**BOARD OF COUNTY COMMISSIONERS
DEPARTMENT OF PUBLIC WORKS
SOLID WASTE MANAGEMENT DIVISION**

Re: Citrus County Central Landfill
Permit No. 21375-003-SO

AREA of breach.

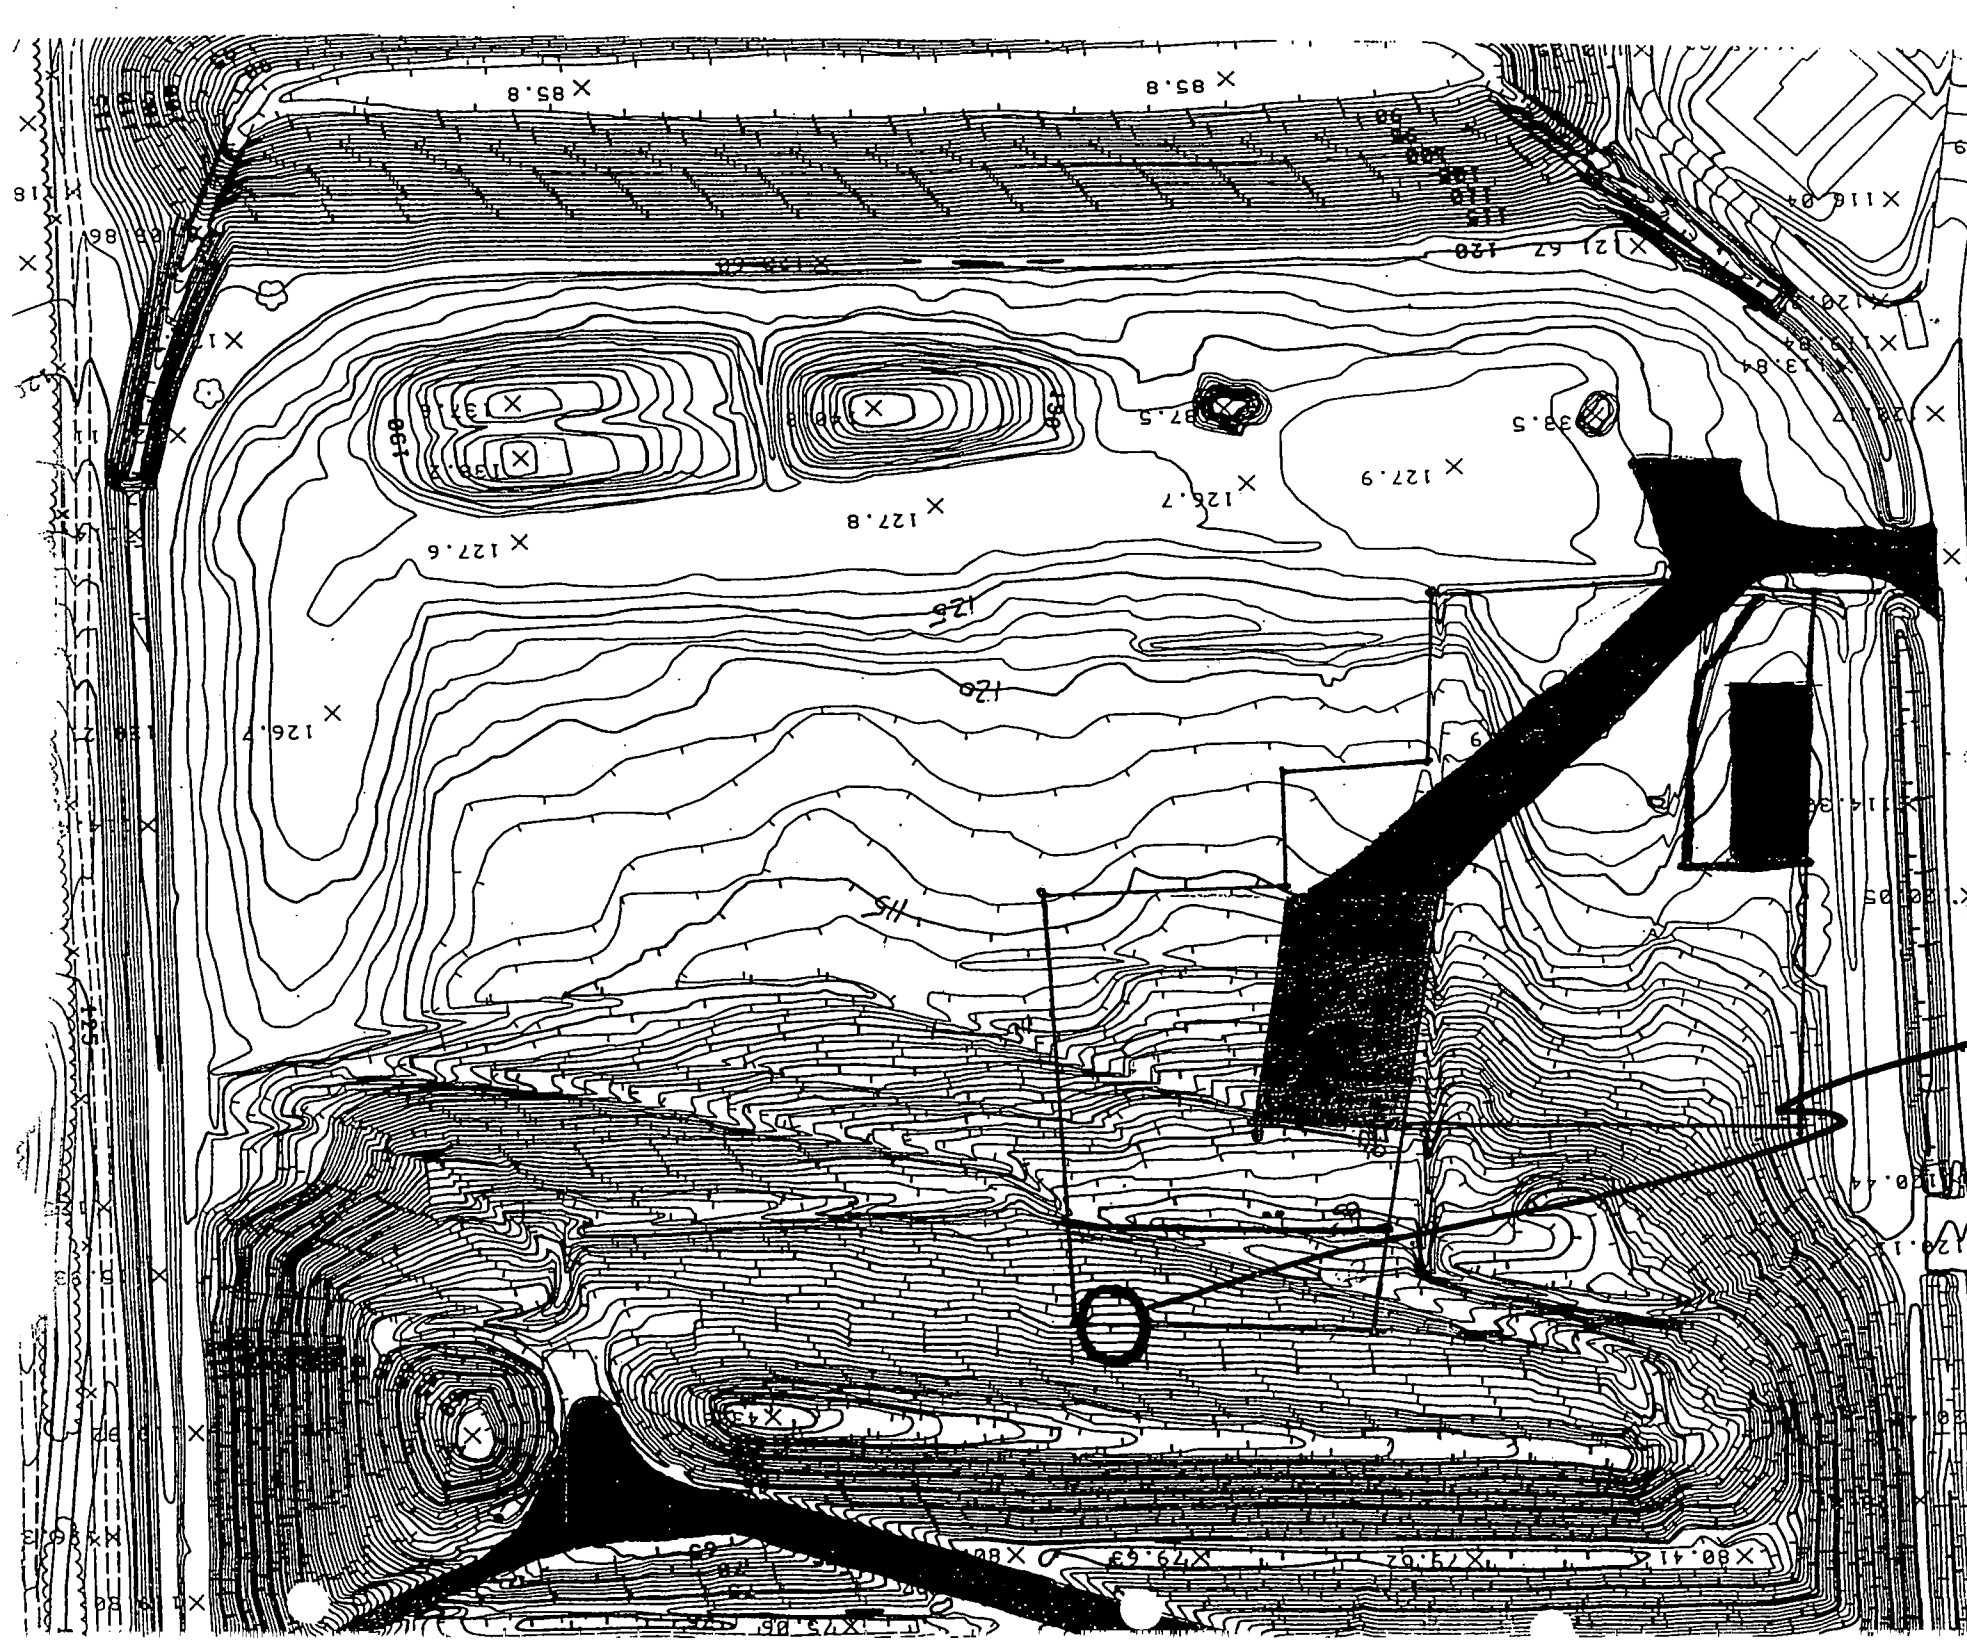
During the early morning hours of Friday December 13, 2002, our facility received over two inches of rainfall, including the overnight period. Upon arriving in the morning, staff members discovered that the berm between the lower end of the fill area and the stormwater system had been breached in one area. As a result, we estimate that 3,500 gallons of contaminated stormwater was released into the stormwater system at the location shown on the attached map. The berm was replaced immediately. When the berm is dried out, it will be reinforced with stormwater ditch liner material on the inside.

**PHOTOGRAPHS OF AREAS OF METHANE DETECTION
AT SHERIFF'S GUN RANGE**

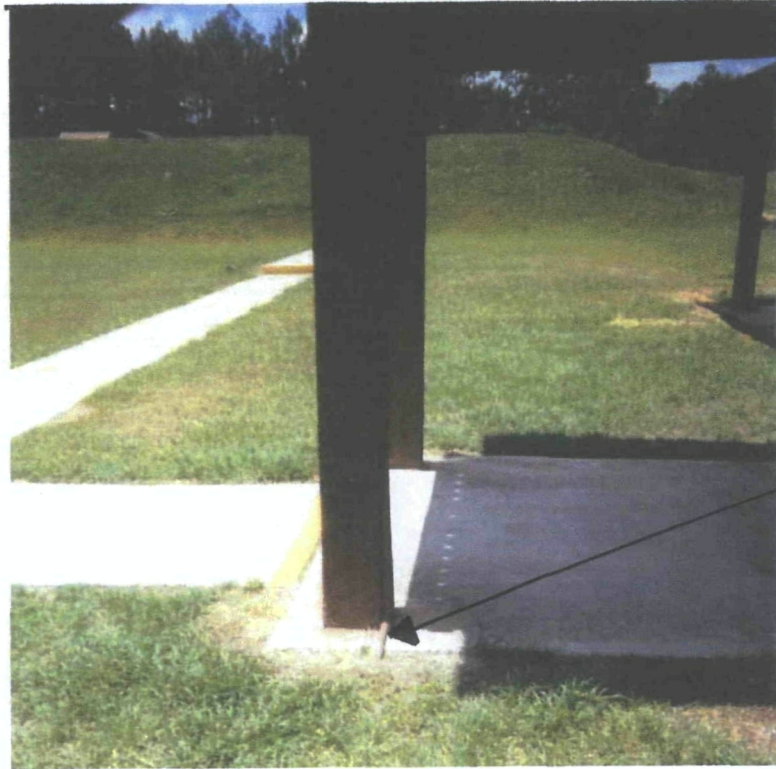
In the gas monitoring report prepared by SCS Engineers for the second quarter of 2002, you noted several items for which you recommended remedial actions for landfill gas safety in the area of the firing range on the closed landfill. WTI personnel who operate that gun range have reported to us that those actions are completed. We will provide the suggested monitoring for the next two weeks. We will inform you, FDEP and WTI if gas is still detected either in the plugged conduits or nearby areas. Thank you for bringing those items to our attention.

Figure 7-1
Typical Working Face

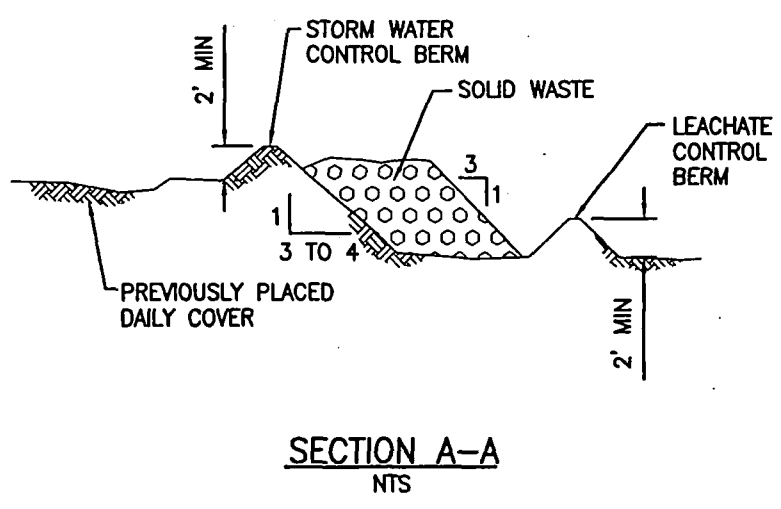
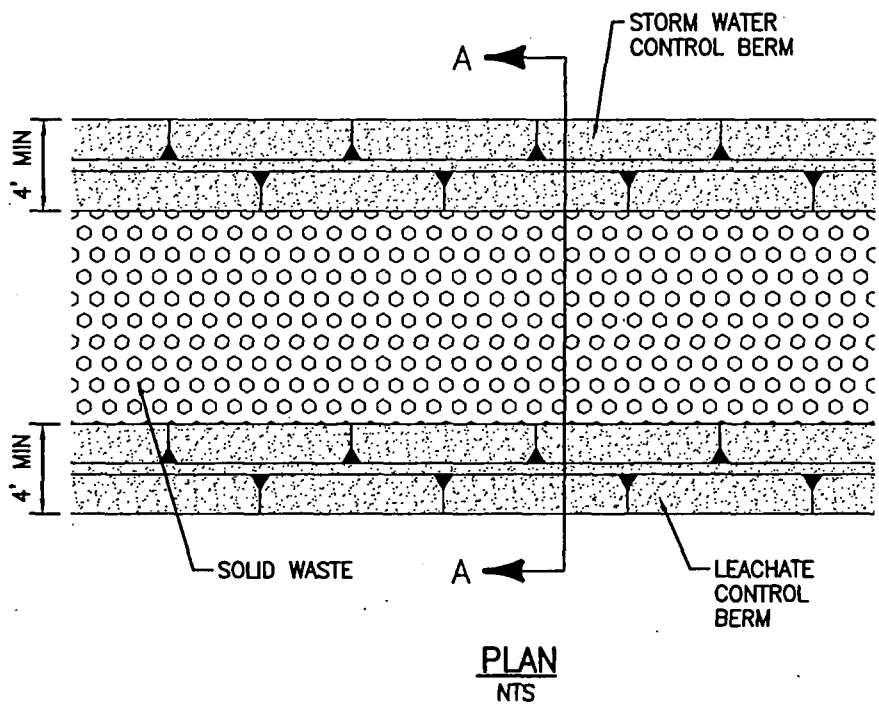
1. 62-701.500(2)(g). Revision to Section 7.1 of the Operations Plan is requested to delete reference to a 10-ton compactor. Equipment specifications indicate the compactor weight is more than 35 tons.
2. 62-701.500(7)(c). Figure 7-1 should be revised to show no steeper than 3 to 1 slopes for the previously placed daily cover over the working face.
3. 62-701.500(9). Revisions to Sections 9.0, 9.1, and 9.2 of the Operations Plan are requested to correctly reference the current LFG Monitoring Plan and delete unclear and conflict descriptions, or to provide a new plan. If the LFG Monitoring Program by CH2M Hill that was received by the Department on October 22, 1996 is still valid, then section 9.0 may simply reference this plan and attach it as an appendix to the Operations Plan.

4. **62-701.500(7)(c)**. The actual maximum slope of the working face is requested. Figure 7-1 should be revised to show no steeper than 3 to 1 slopes for the working face.

The working face will be sloped at a maximum of 3 feet horizontal to one-foot vertical rise. The lift depth will be a minimum of 10 feet. A plan and cross-section of a typical working face is shown on Figure 7-1.
